CBX25UH and CBX25UHV Air Handler Enhancement

Additional Technical Changes

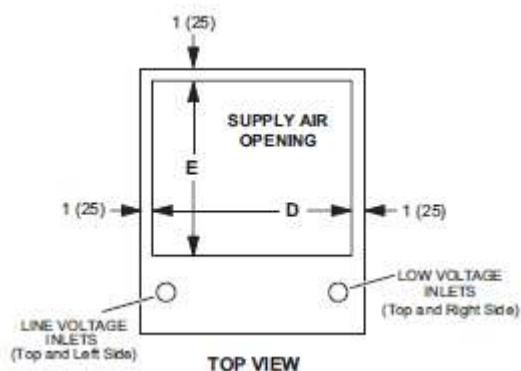
- The height of the 3 Ton CBX25UH will increase to 52.5 inches from its current 48 inches. As a result, a new catalog number will be made available for this unit. No other catalog numbers will be changed.

- The depth of the supply air opening on both the CBX25UH and CBX25UHV has been changed to the following dimensions.

- The 10kW electric heat option for the 1.5 ton CBX25UH will not be available on the new version units. However, the 10kW option will still be available for the 2 ton and all other tonnages. The 10kW option will still be available for the CBX25UHV 1.5 ton unit.

- Due to the rerouting of the suction and liquid lines to improve TXV bulb placement, their location on the front of the unit has been changed. (See EHB included with this product kit for more details on the new line locations). As a result, replacement coils for the new unit will be backward compatible with the old unit with the addition of a new cover plate that will be shipped with each replacement coil. However, replacement coils made for the original unit will not be forward compatible to the new unit. Therefore it is necessary to order the new replacement coil part number if replacing a coil in one of the new units. The new replacement coil part numbers are as follows:
